SCHEDULE OF SUBMISSIONS (PUBLIC SUBMISSIONS)

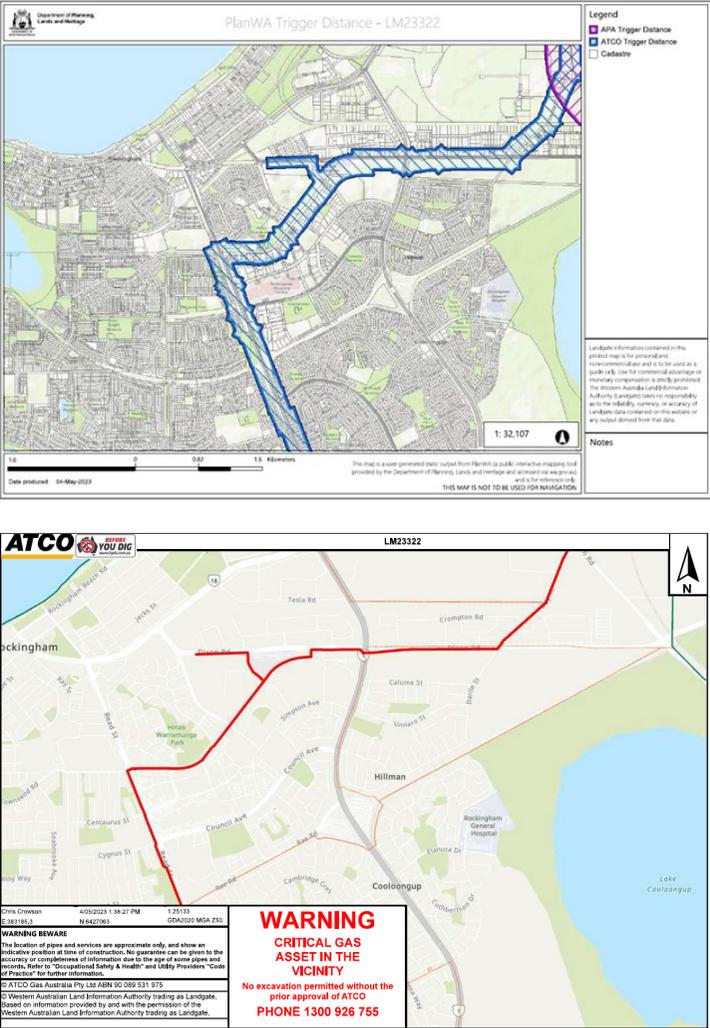
<table><tr> <th>No.</th> <th>Page</th> <th>Section</th> <th>Rev 1 -DWER Comments</th> </tr><tr> <td>2</td> <td>8</td> <td>Section 2.2 - WMS Objectives</td> <td>Reference to sub-surface drainage (subsoils) should state that they are to be set at or above</td> </tr></table>

No.	Page	Section	Rev 1 -DWER Comments	1		General Comments	Please ensure that references to DoW are changed to DWER (Department of Water and Environmental Regulation)	2	8	Section 2.2 - WMS Objectives	Reference to sub-surface drainage (subsoils) should state that they are to be set at or above	<p>Based on correspondence with DWER, it is understood that DWER's primary concern is that more information is required as part of the Water Management Strategy to better understand the impacts future development will have on surface runoff. One of the primary drivers for this additional work, is that the existing drainage infrastructure cannot accommodate any additional flows into Lake Richmond.</p> <p>It is the expectation of DWER that areas subject to higher densities would fall within established urban catchments which drain to existing flood storage areas. The task would be to determine if those existing flood storage areas have the capacity to hold (if any) additional stormwater runoff calculated. If existing flood storage infrastructure is not capable of accommodating extra stormwater runoff, the Structure Plan must consider what options there are for additional storage within each catchment.</p> <p>The only existing City infrastructure to be 'assessed' would be the ultimate capacity of the relevant existing flood storage areas.</p>	<p>The Water Management Strategy (and any relevant sections of the Structure Plan) to be updated in collaboration with DWER / Water Corporation.</p>
No.	Page	Section	Rev 1 -DWER Comments													
1		General Comments	Please ensure that references to DoW are changed to DWER (Department of Water and Environmental Regulation)													
2	8	Section 2.2 - WMS Objectives	Reference to sub-surface drainage (subsoils) should state that they are to be set at or above
